BLOOMINGTON HISTORIC PRESERVATION COMMISSION

Thursday February 13, 2014

AGENDA

WEST ELEVATION

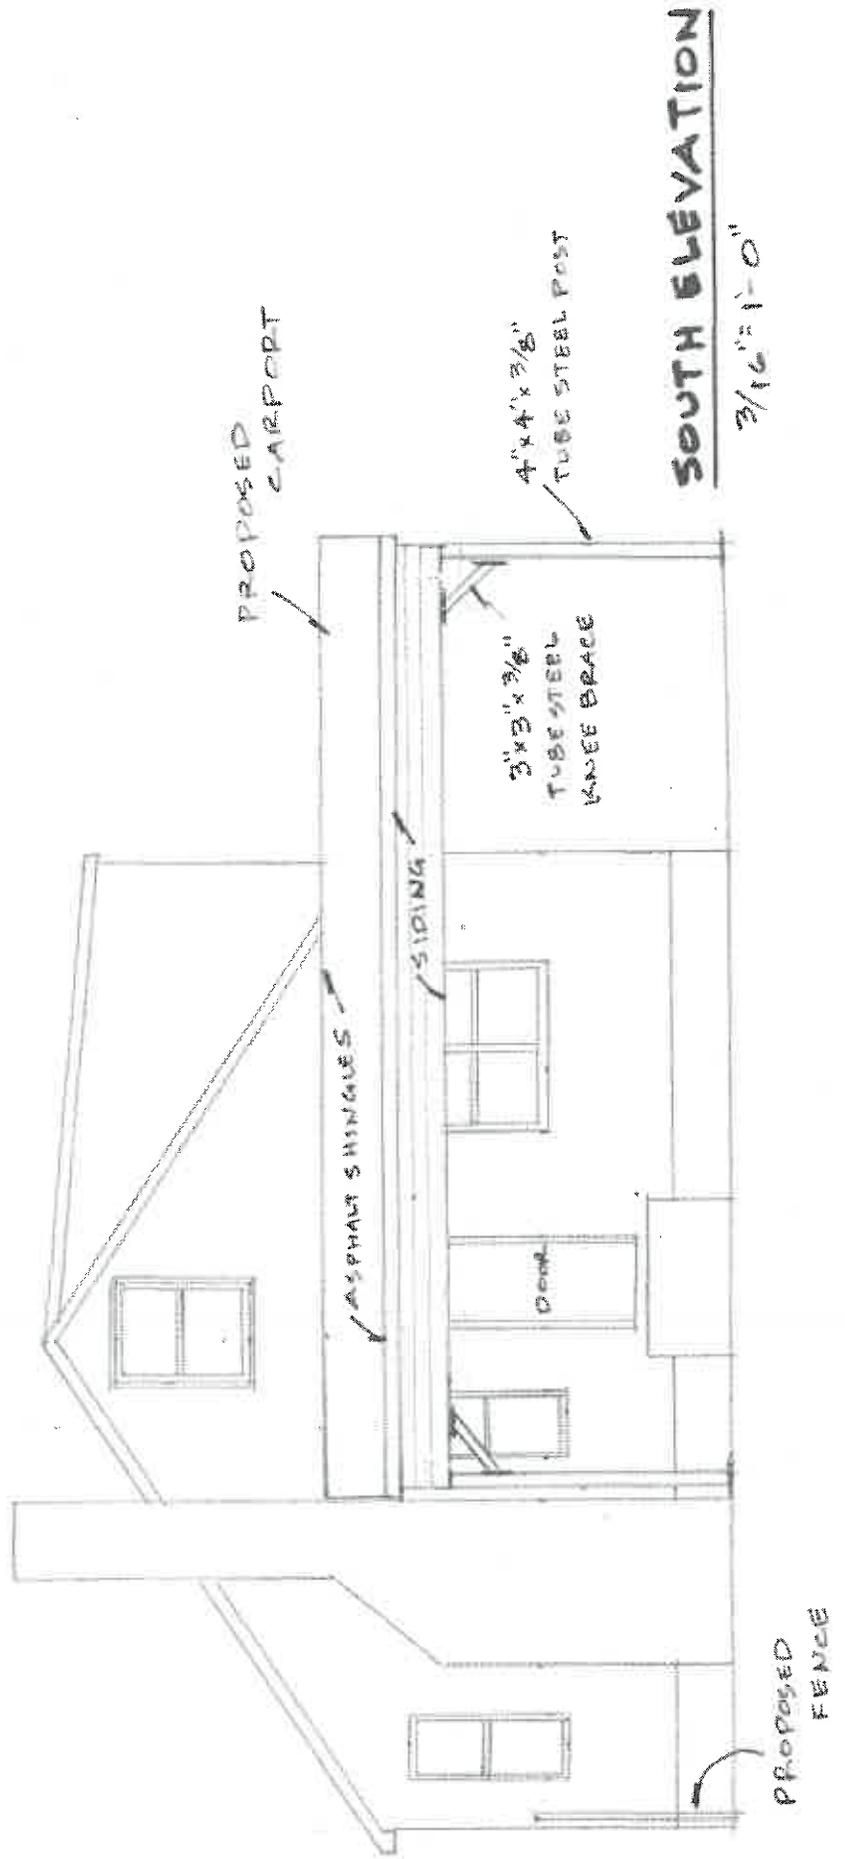
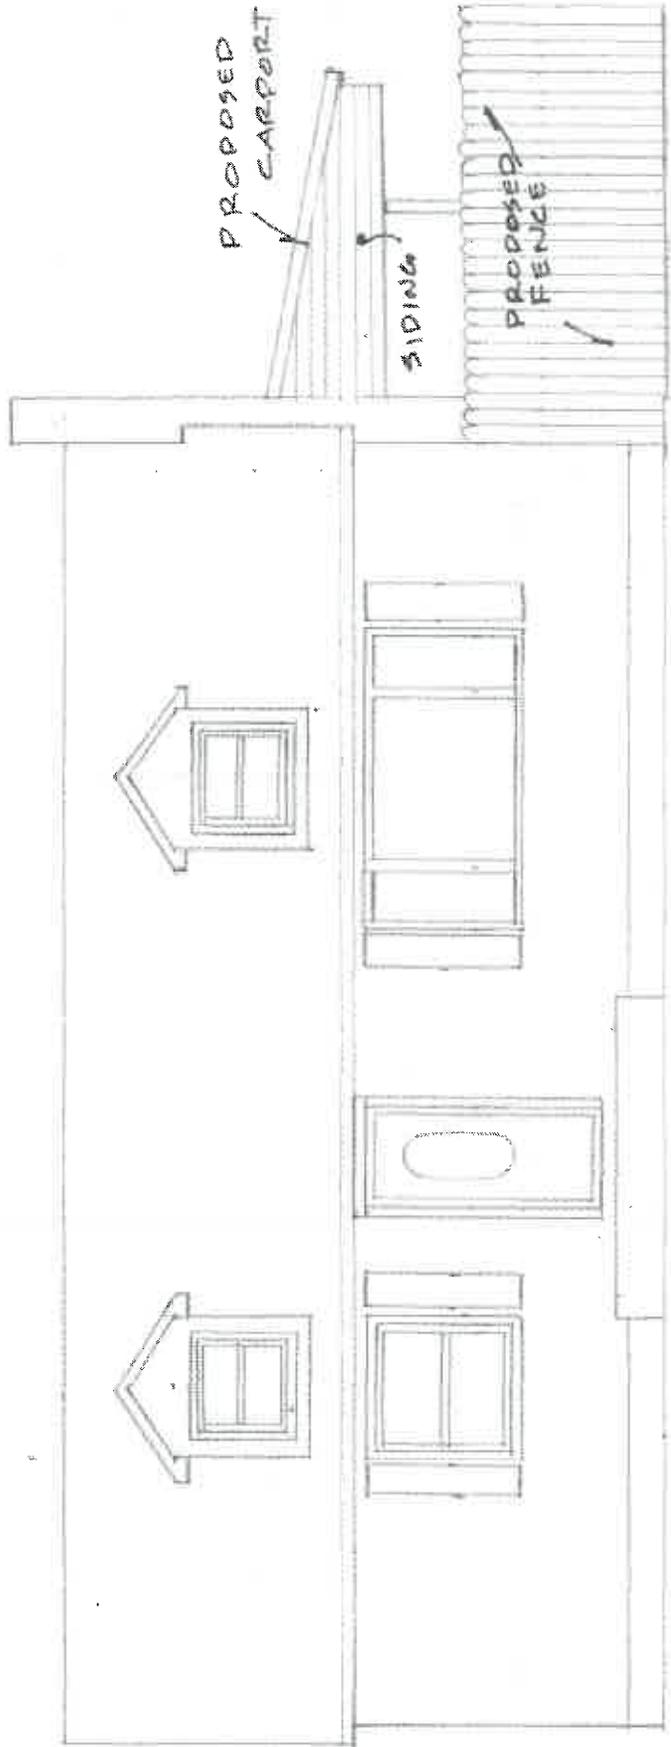
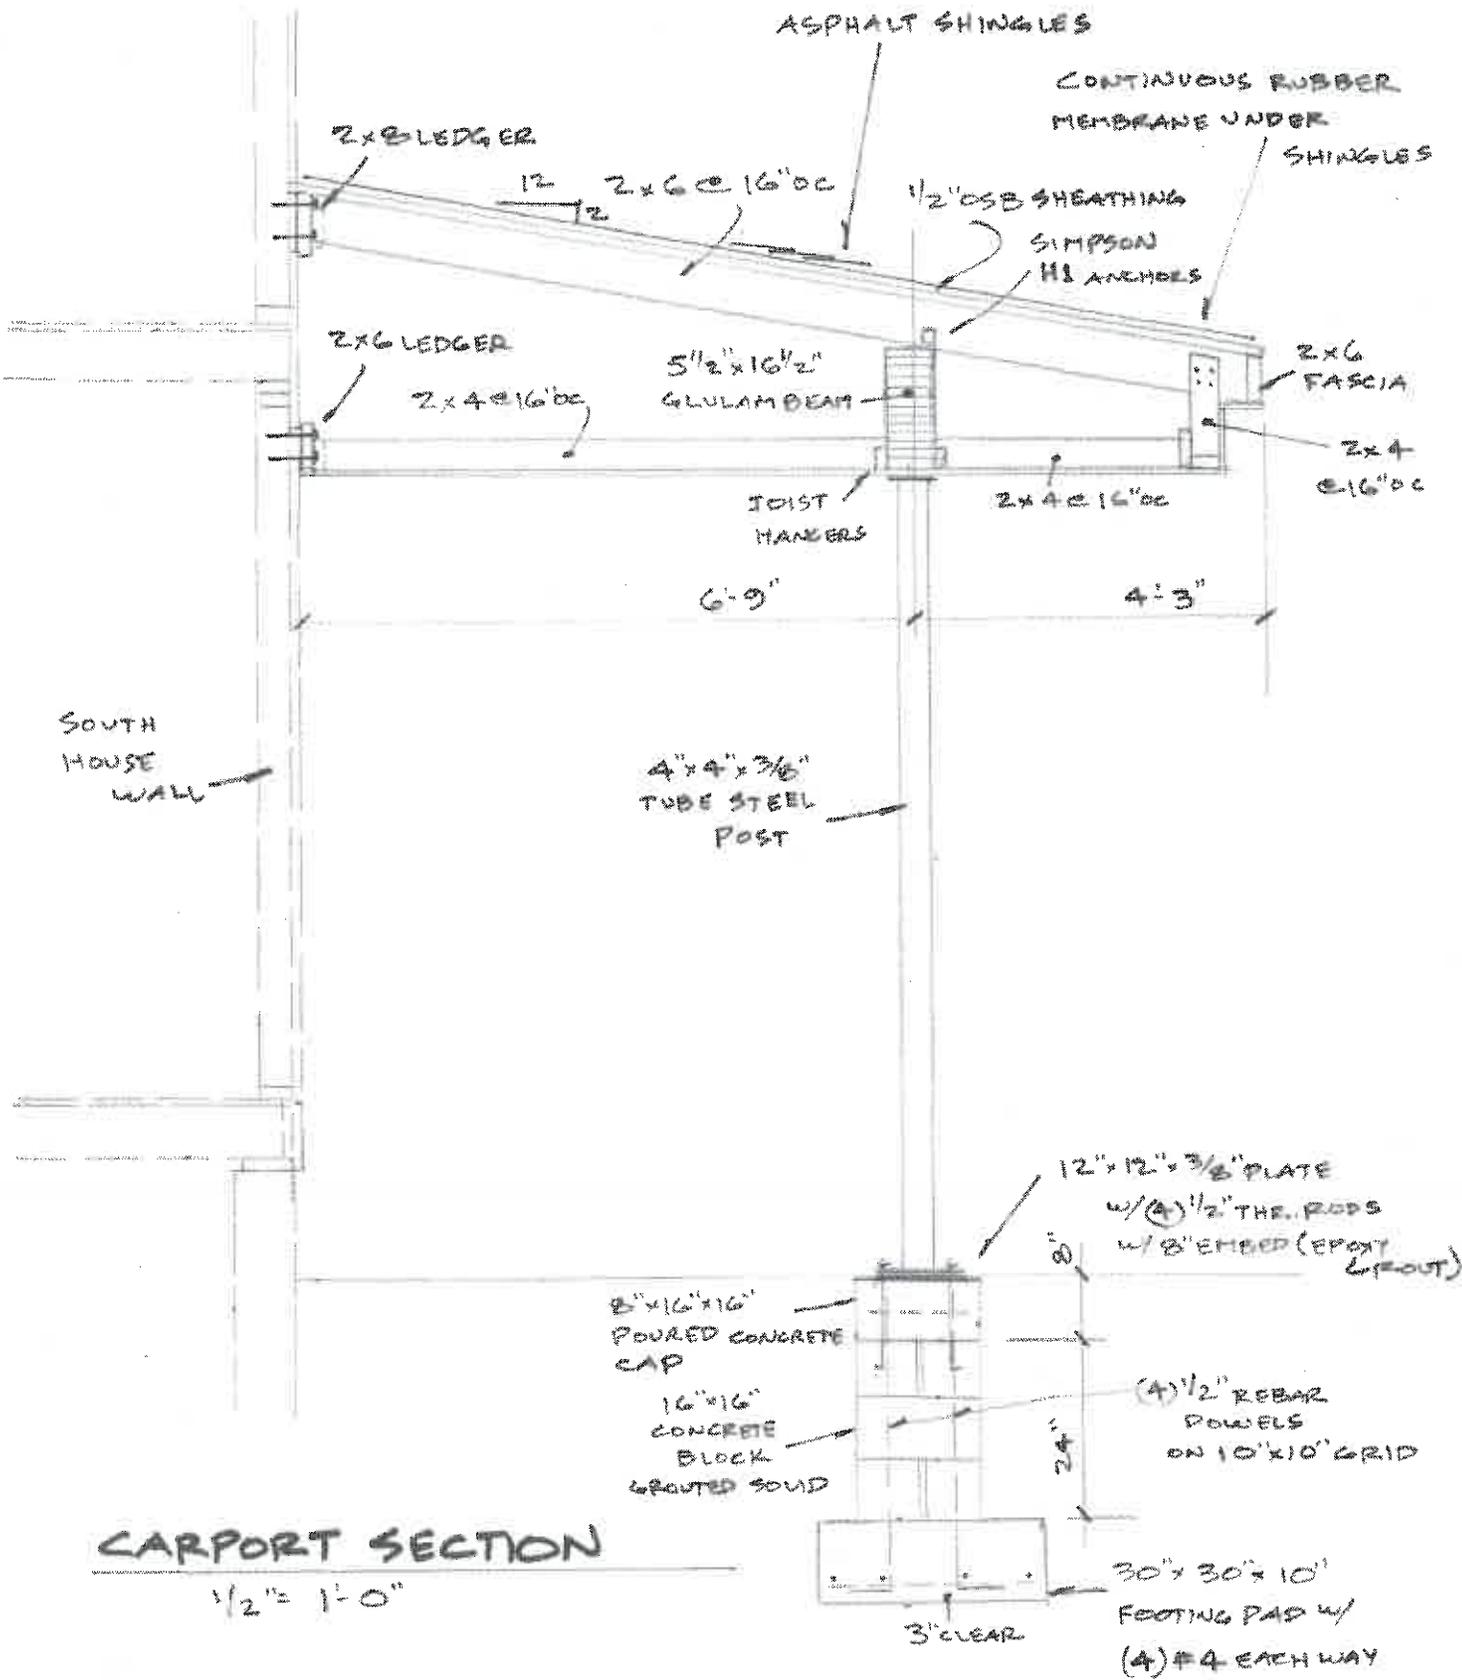
New construction will include an approximately 28' x 11' carport affixed to the south side of the house behind the chimney, as well as a screening fence and textured drive. The roof will be located in the area of an existing side entrance, stoop and paving. The

original pent roof over the entrance will be removed. Currently there is no garage on the site, only a paved apron off the alley at the approximate location of the proposed carport. The plans include a privacy fence to be attached to the front wall of the house to mask the storage area from the street. The carport lean-to roof will be covered with shingles to match the house and supported by tube steel posts. A skirt of siding

Both of these guidelines rather clearly refer to historic forms in the neighborhood that were identified as appropriate for particular styles and forms of housing in Elm Heights. This house is mid-century modern with significant alterations. The use of metal posts is not considered a problem for this era of housing.

The proposal does meet some of the above criteria directly: The car storage uses the alley as access and the area will be masked from the street by a privacy fence. The idea of a carport is fairly unique in Elm Heights (there are a few on much more dramatically modern homes with good integrity and some used inappropriately on older homes) but considering the age of the structure, a carport is not inappropriate. The placement of the rear yard fence is not in compliance "the fence should be set back midway from the front and rear of the house" but it serves a purpose of screening the car storage. Staff does see some awkwardness in placing the fence directly in line with the front wall of the house and if this placement wasn't chosen for a reason, perhaps a few feet of setback would be more compliant with the design guidelines and still mask parking. The use of stamped concrete in a "cobblestone pattern" is probably not a concern because it will be screened from the street. This might be considered historicizing the site if made into a prominent feature on the lot. It is undoubtedly an improvement to the deteriorated concrete that is present.

Staff recommends approval with the suggestion that the screening fence be placed farther back on the house.
